PLANNING COMMISSION REPORT
Regular Agenda – Public Hearing Item

PC Staff Report
04/25/18

ITEM NO. 2 SPECIAL USE PERMIT FOR BISHOP SEABURY; 4120 CLINTON PKWY

SUP-18-00076: Consider a Special Use Permit for a 30,342 SF SF building addition at Bishop Seabury Academy, to accommodate additional classrooms, office, cafeteria/kitchen and chapel spaces, located at 4120 Clinton Parkway. Submitted by BBN Architects Inc, for Bishop Seabury Academy, property owner of record.

Figure 3: North access Drive to Service Area

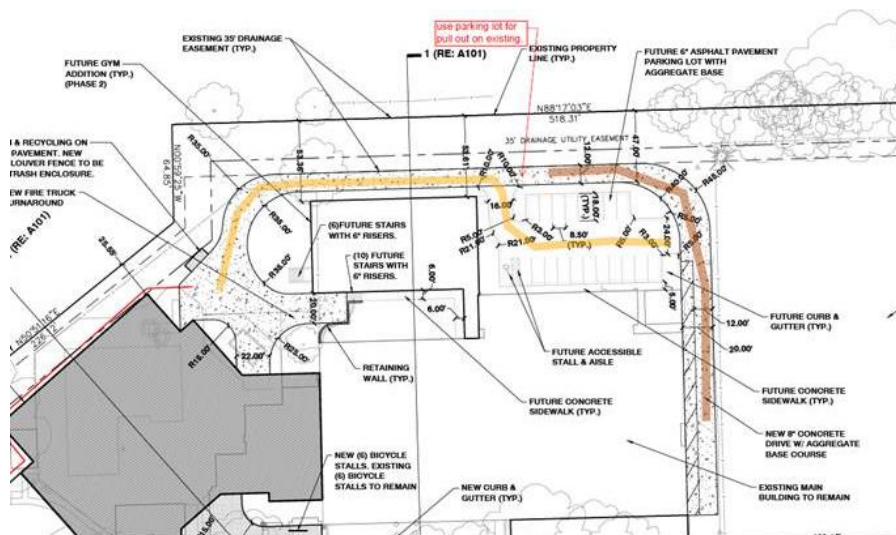
The existing site includes an existing 20’ wide drive along the east side of the building providing access to the service area of the building. This drive will provide access to the new proposed parking lot. The width of the existing drive is less than 24’ and is not proposed to be widened with this project. The new parking lot includes a code compliant 24’ access aisle. Widening the drive will future encroach into the existing multi-purpose athletic field and the regulatory floodplain area. The current drive is not within the regulatory floodplain area of the site.

The perimeter driveway is extended along the north side of the site parallel to the 35' drainage easement along the north property line. This segment is 12' wide. This drive extends west to the service area in the rear of the building and includes a 16' wide driveway to the north side of the new parking lot. The width of the drive is limited by the existing improvements and the wide drainage easement. Widening the drive encroaches into the easement, disrupts surface drainage and encroaches on the sanitary sewer line. Pass by traffic movements will need to use the new parking lot which will accommodate two-way traffic as needed. The 12' wide access drive is intended only for service delivery, solid waste service, and emergency access as needed.

1. Reduction of required bicycle parking from 43 to 12 as determined to be acceptable by the City Engineer.
2. Waiver to reduce required perimeter parking lot landscaping due to underground utility conflicts.
3. Waiver to reduce the width of the north and west access driveway as shown on the site plan.

Figure 4: Parking Lot view from Clinton Parkway

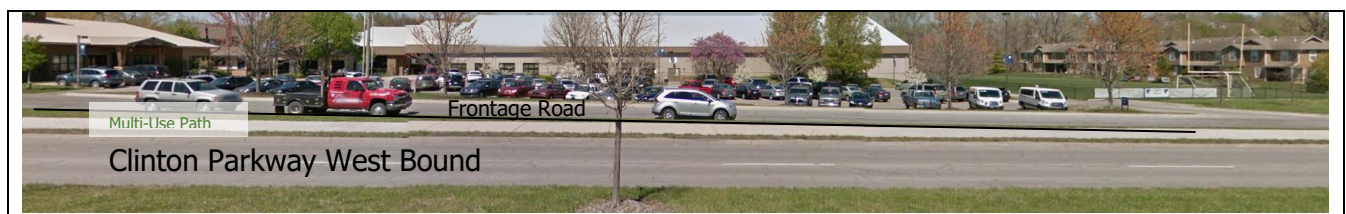
Parking lots abutting public right-of-way are required to be screened with fences, landscape and or berms. The previously approved plan included shrubs along the south property line to show compliance with this design standard. These plants would have been located in the public right-of-way. These plants are missing from the site and were not installed as required. The proposed site plan shows a new landscape plants for perimeter screening that accounts for the limited planting area that is restricted by existing underground utilities.

A 24" water line is located south of the parking lot. In addition to the municipal water line, other underground utilities are located in the right-of-way. Plantings must be 8' from water and sanitary

Staff Response: Both the Utility Engineer and the City's Horticulture/Forestry Manager concurs that the addition of trees in this green space is not feasible. However, it is possible to plant small shrubs in specific locations. The full screening of the parking lot is not possible because of the existing utility locations. The proposed landscape landscape plan provides additional shrubs that will screen some of the perimeter parking lot along Clinton Parkway. This is preferable to granting a waiver. Staff recommends the waiver be denied and that the plan be revised to provide minimal landscape, per the approval of the City Horticulture/Forestry Manager.

Figure 5: Proposed Landscape Plan – Street trees are located in public ROW

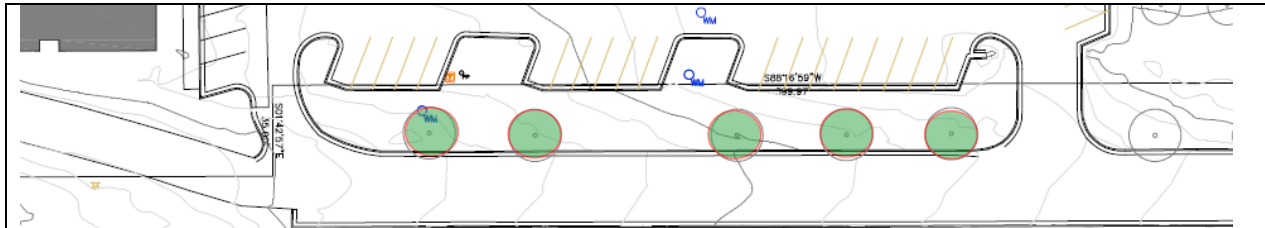
sewer lines. The applicant is requesting a waiver from compliance with the design standard to add additional shrubs as discussed below.

Applicant Justification: *"Due to site constraints (Multiple utilities running the length of the island, including fiber, phone, gas, electrical and 24' main water line); we request a waiver of this recommendation per section 20-1004. Additionally, Clinton Parkway Frontage Road does not function as a public thoroughfare in this location. It terminates at Seabury and there is no cul-de-sac."*

Figure 8: Type 1 Required Bufferyard Areas per 20-1005

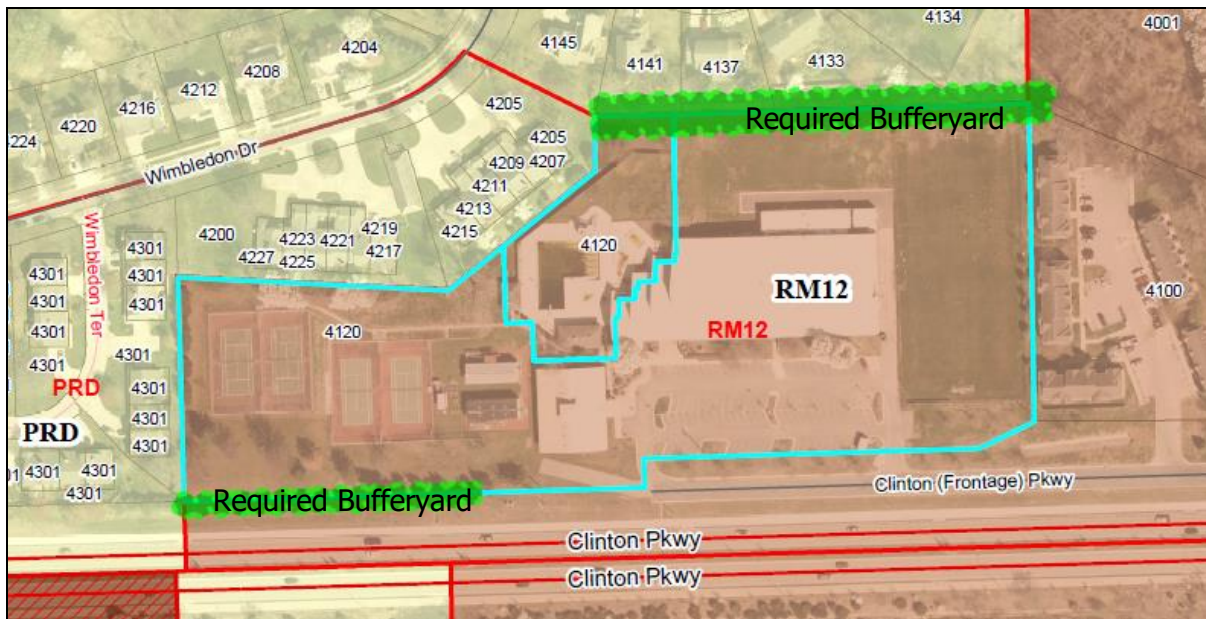
directions. The adjacent property zoning includes RM, RS and Planned Unit Development District zoning. A bufferyard is required where RM and RS Districts are adjacent. The bufferyard applies to the portion of the north property line adjacent to RS7. The following figures show the location where bufferyard requirements are applicable to this development. The Land Development Code prescribes a Type I bufferyard with options for 10, 15, 20, and 25’ widths and corresponding landscape planting requirements. The proposed site plan shows a 35’ wide buffer yard with new vegetation along the north property line parallel to the building and existing vegetation along the north side of the athletic field along the east property line.

Figure 9: Bufferyard PUD to RM12

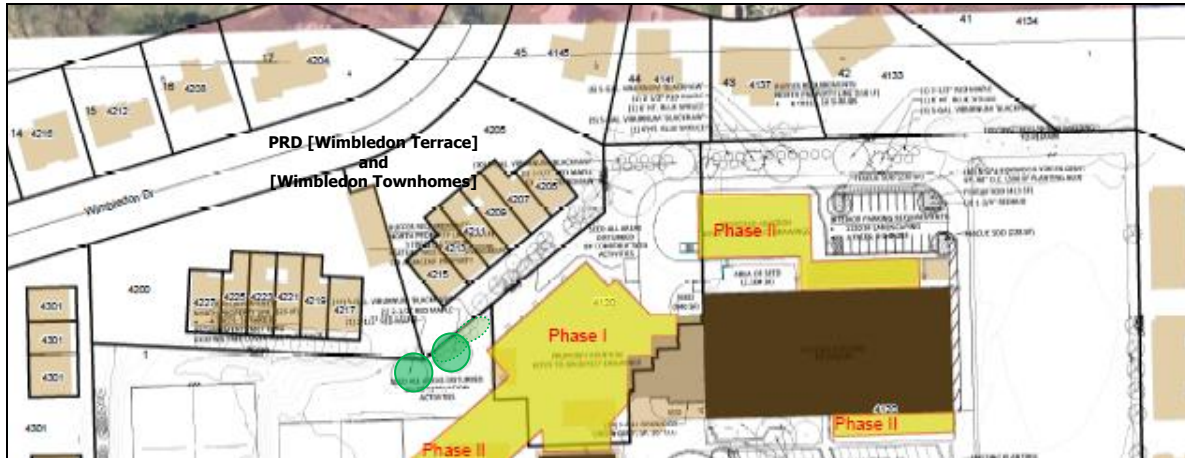
This property abuts residential development with access to Wimbledon Drive to the north. Per Code, screening is not required along this segment of the north property line. However, residents have expressed concern about the project and screening between the residences to the north and the proposed building additions. The plan submitted includes new trees and shrubs located along a portion of the north property line to augment the existing trees located on the residential side of the property line.
